November 22, 2024

Project: **Proposed 38-Lot Woods at Viewcrest Plat**  
352 Viewcrest Road, Bellingham, WA

Subject: **Geohazard Review Addendum – Stormwater Outfall Plan**

STORMWATER OUTFALL

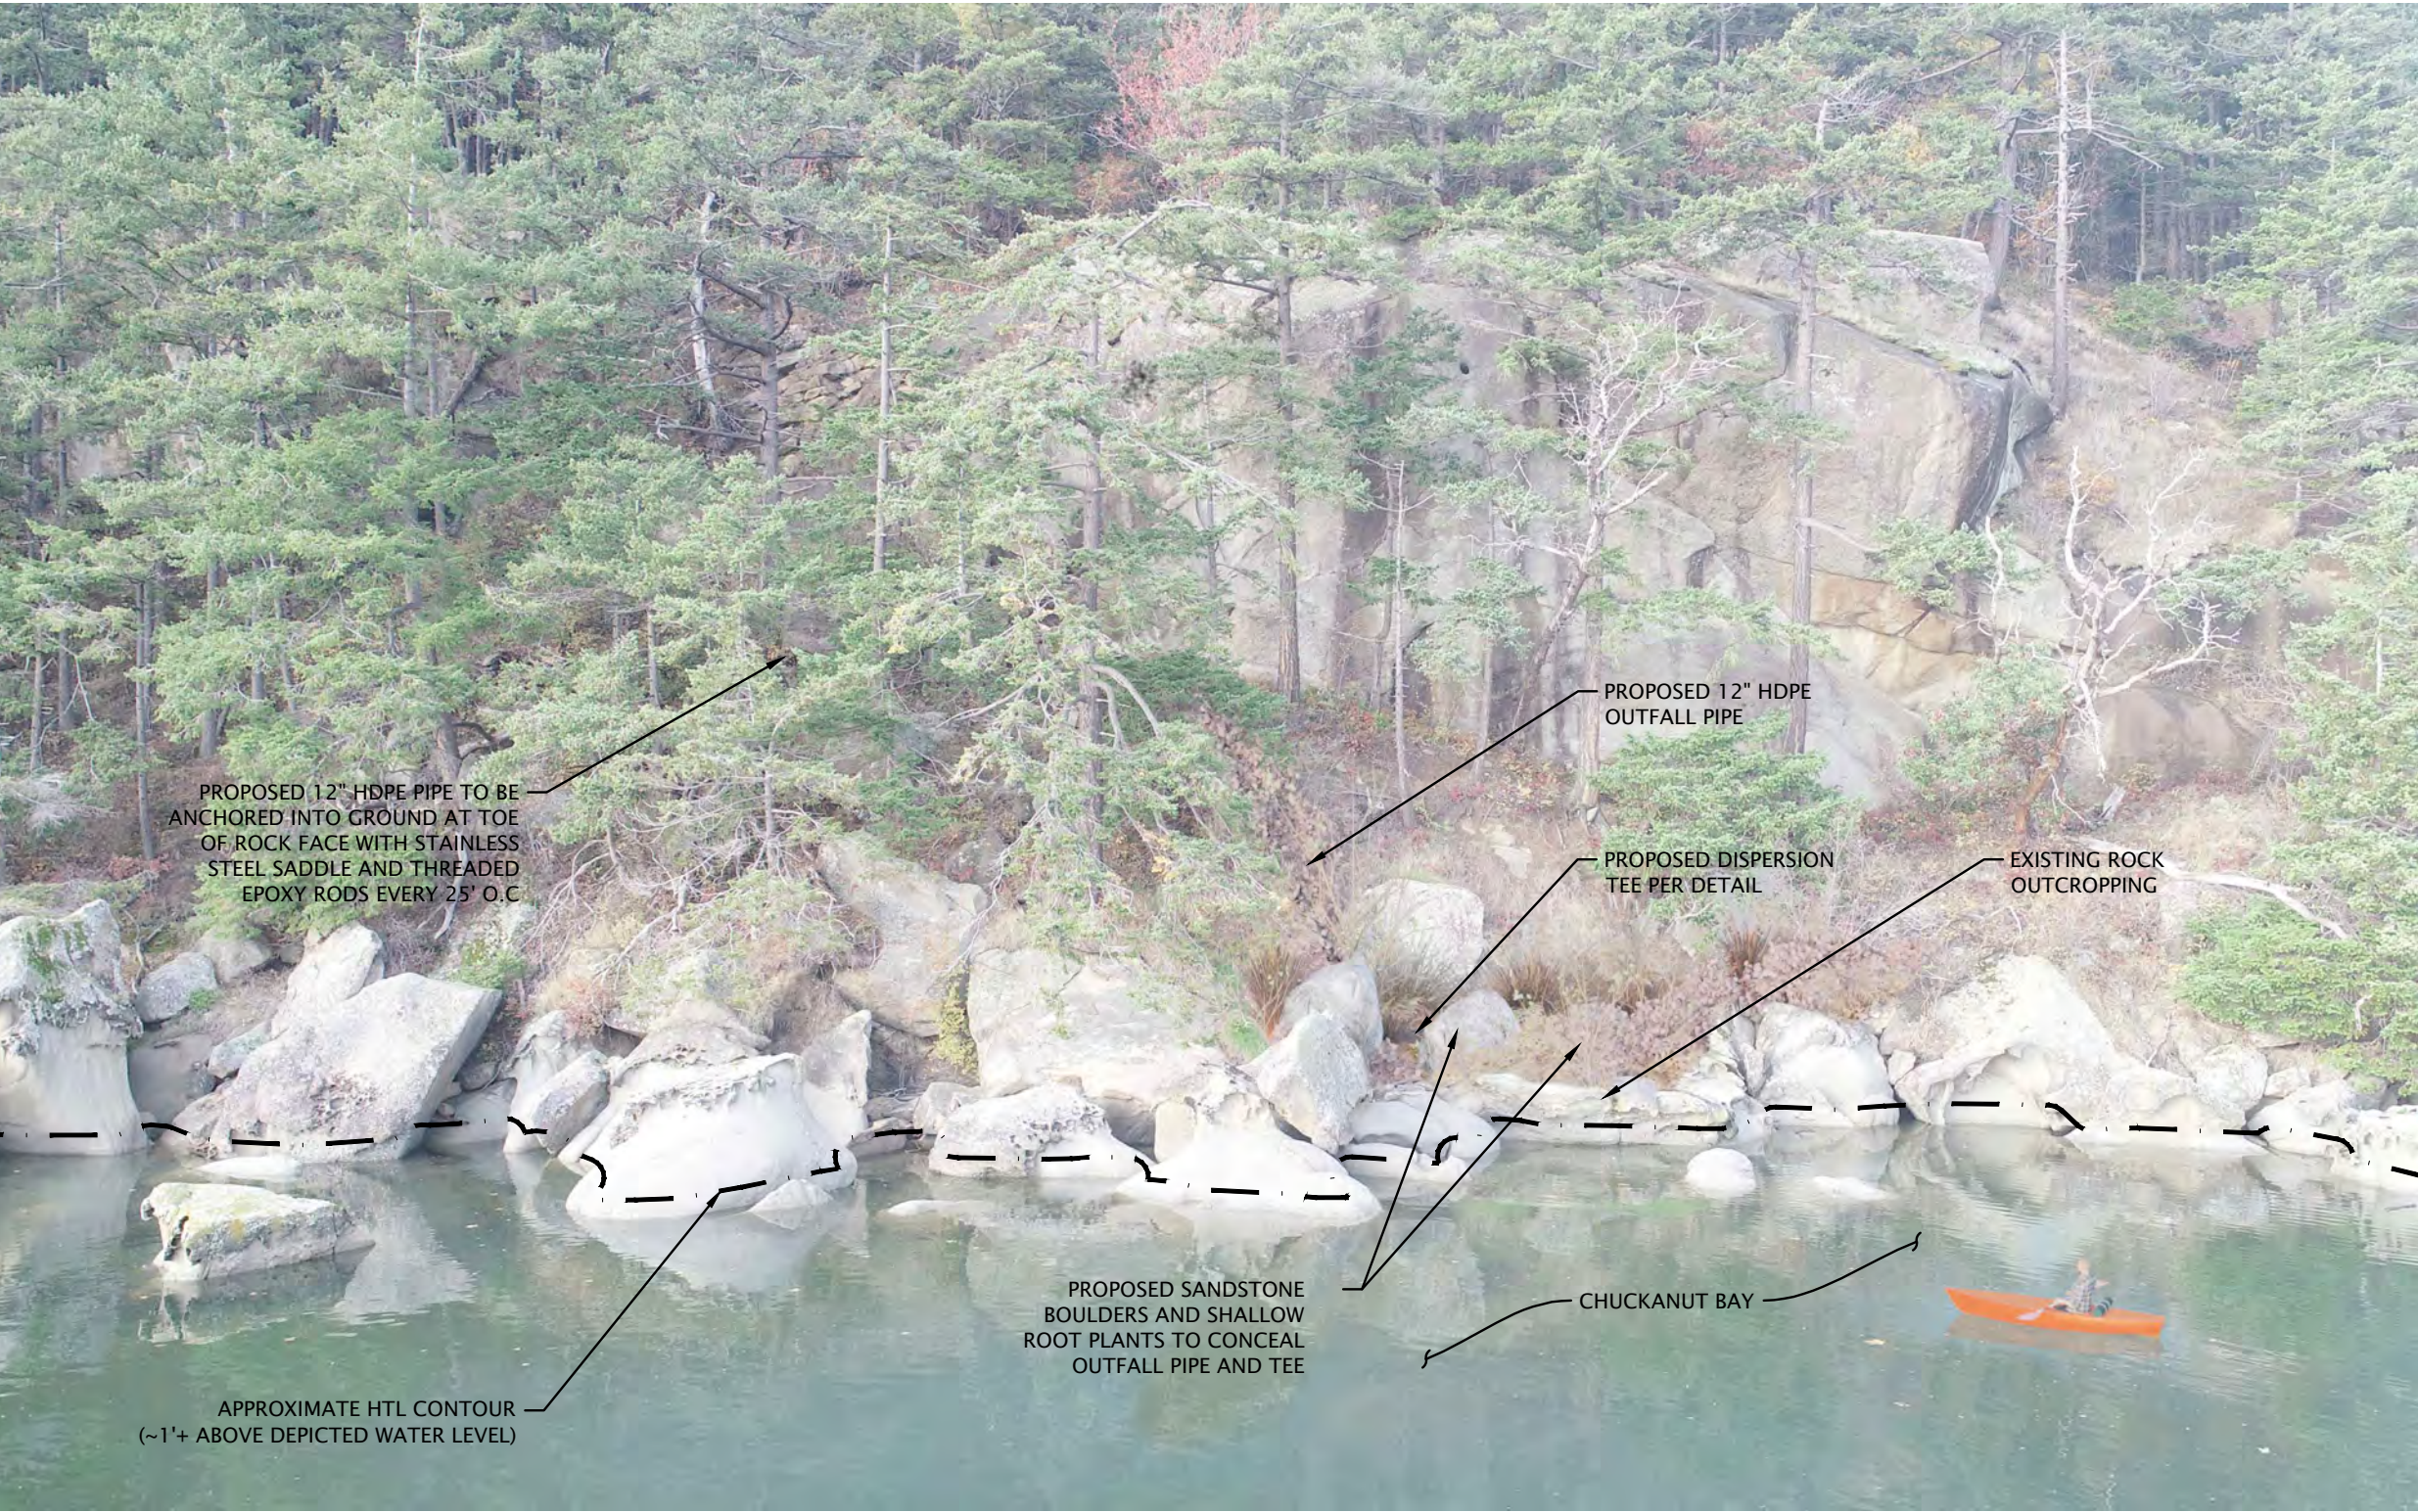
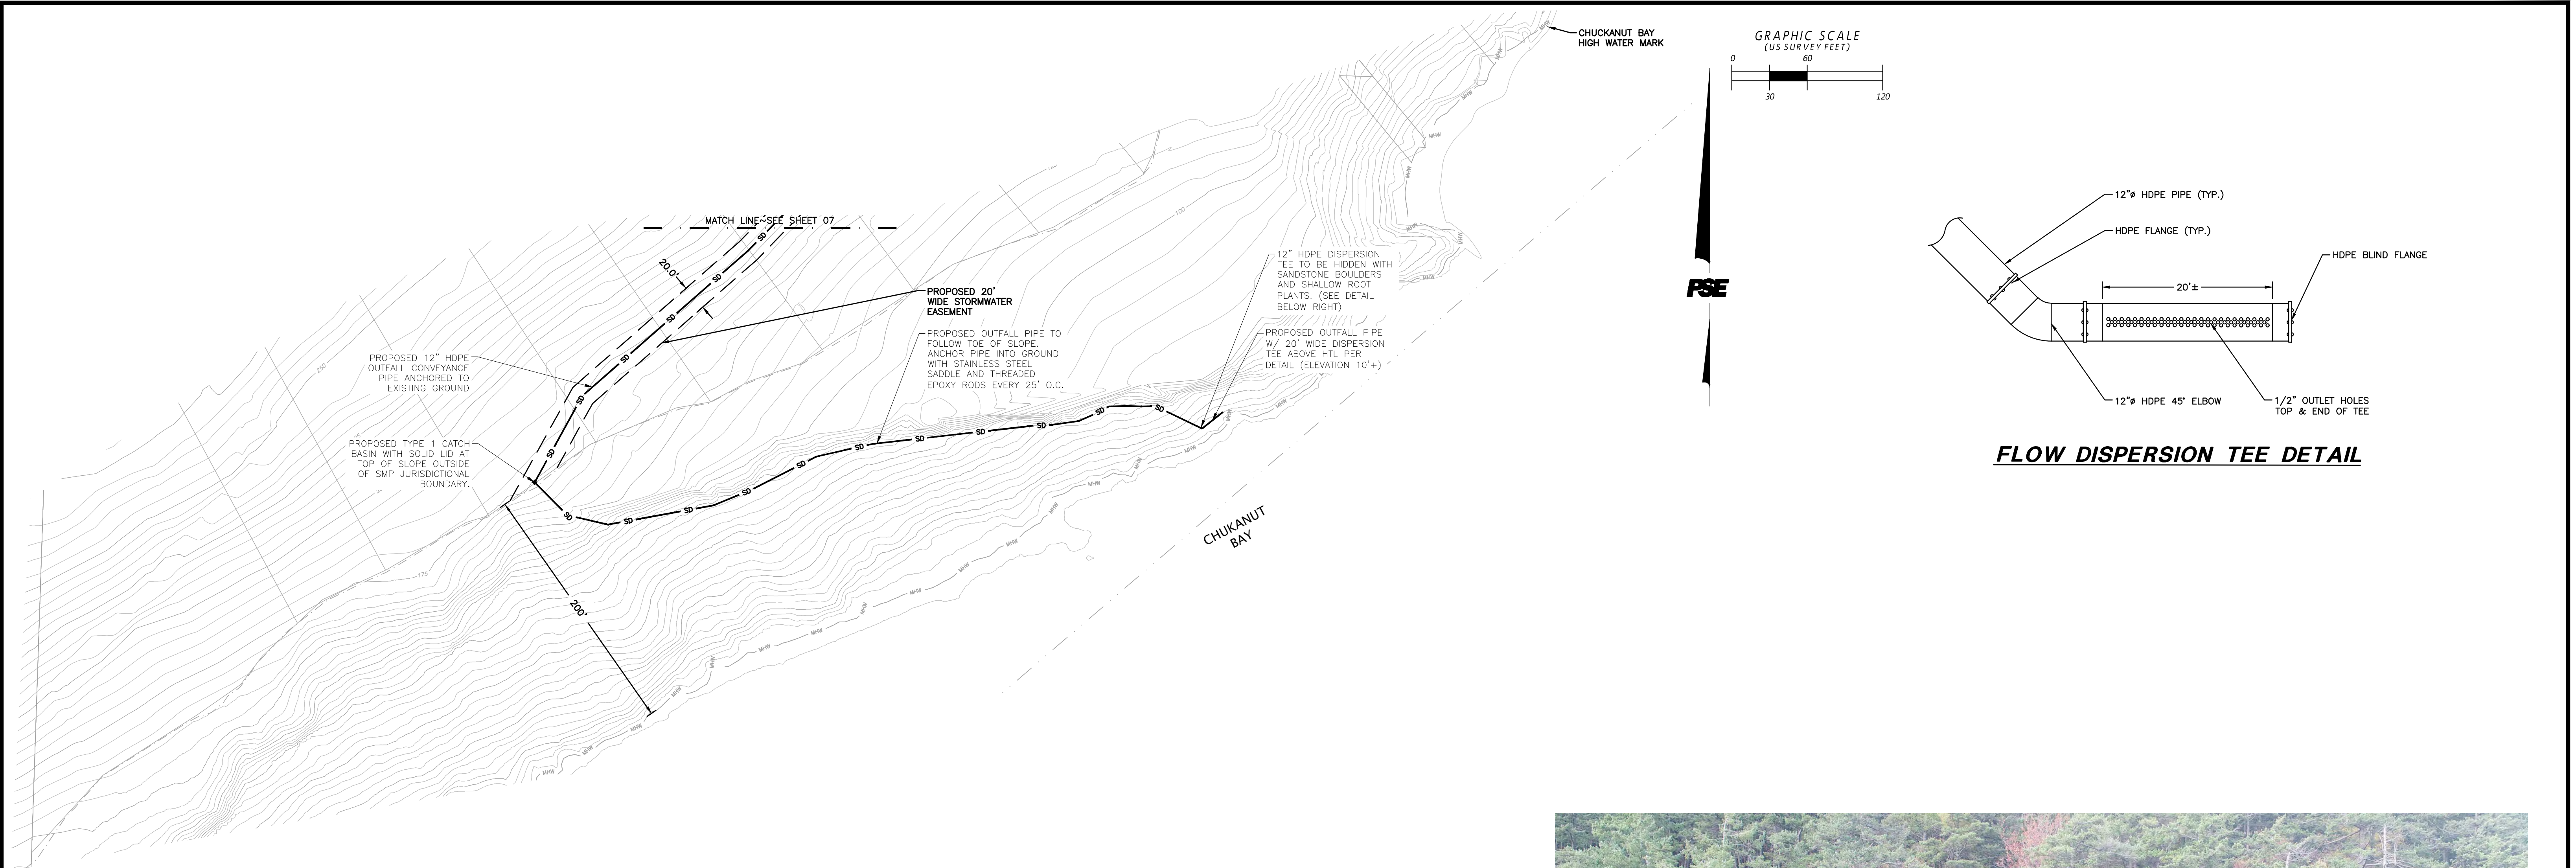
Two areas of greater-than-typical challenge for tightline installation have been identified which pose unique difficulties that must be addressed in final design and construction. The approximate locations and extents of these areas are noted on Figure 3. For the purposes of this review, we have assumed that the general routing concept as shown on the Preliminary Plat drawings will be pursued for final design.

**Upland Slope Small Outcrop Zone:** This zone may present difficulties for conveyance pipe construction and long-term outfall security due to the variability in topography as a function of the local rock outcrops. With careful planning and preparation of a suitable corridor the depicted route is expected to be viable, although pipe installation could incur greater-than-typical efforts and costs to do so.

- We encourage additional detailed reconnaissance and collaboration during final design to assess for routes for optimal avoidance of specific outcrop obstructions. For instance, an angled segment through Lots 30 and 31 may be considered as an alternative to the right-angle junction shown.

**Bluff Slope Rock Fall Zone:** After descending onto the lower bluff slope, the conveyance piping is proposed near the base of the tall rock exposure. While the eastern majority of this rock face appears intact with a low rock fall risk, the western portion appears prone to occasional rock fall from fractured outcrops. In particular, the first approximately 100 feet along the cliff face displays an elevated risk of incidental rock fall. This is evidenced by common rock talus on the underlying slope which generally dissipates out from the outcrop. The next roughly 100 feet of slope also has common older rock debris but little evidence of recent activity.

- One method to mitigate rock fall hazard from the cliff band is to adjust the alignment to traverse across the slope further away from the cliff exposure below elevated hazard areas. The hazard of rock fall directly impacting a downhill pipe generally lessens with distance from the source.

- A downslope shift on the order of 50 feet is interpreted to be sufficient to minimize rock fall impact risk, based on conditions observed during the recent reconnaissance. We recommend an alignment shift below the elevated hazard areas be considered for final design. Site conditions should be re-observed during final design to optimize the outfall path for rock fall protection.

- Constraints on pipe elevations appear to allow for such a downhill alignment adjustment while retaining suitable fall to reach the proposed terminus location. Our observation and map review of the conveyance zone also indicate there is adequate room along moderate slope areas to allow for an adjusted pipe alignment.

- Alternatively, or in tandem with a shift, the conveyance pipe should be constructed with additional shielding from rock fall impacts as needed for the final design location. Possible options include natural barriers (use of existing rock talus and large boulders for upslope shielding), or sleeving / covering the HDPE pipe with another material for impact protection where necessary (like concrete or steel casing).

- In addition to the above protective mitigations, shallow burial or inset of the pipe into natural topography will help minimize the potential for dislodged rolling or sliding rock debris to “catch” on the pipe as it travels downslope. We recommend the pipe placement be optimized to minimize a surface debris “catch” hazard by use of shallow embedment.
